2018 Clarifications

This is the last set of clarifications that will be issued for the 2018 round. The deadline to submit clarification questions was 12:00 noon on Friday, March 23, 2018. We look forward to receiving your Applications by 4:00 pm Mountain Standard Time on April 2, 2018. (Arizona does not observe Daylight Savings Time.)

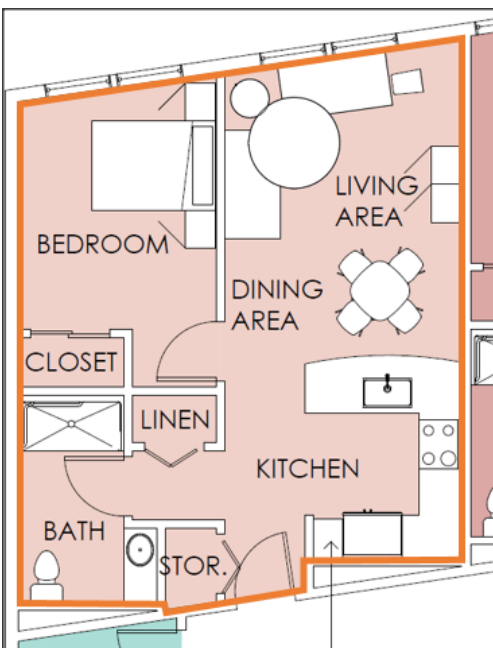
With regard to the definition of “Residential Floor Area”, when ADOH says “paint to paint of the interior of the perimeter walls” are they counting interior walls in the units as part of the residential floor area?

Yes. Residential Floor Area “means the total net square footage of the floor space in all Units (measured from paint to paint of the interior of the perimeter walls) including closets within the Units and balconies (to the exterior edge of any railing) attached to the Units for the sole use of the tenants occupying the Units.”

In the example to the left, all of the area within the darker orange line is included in the Residential Floor Area.
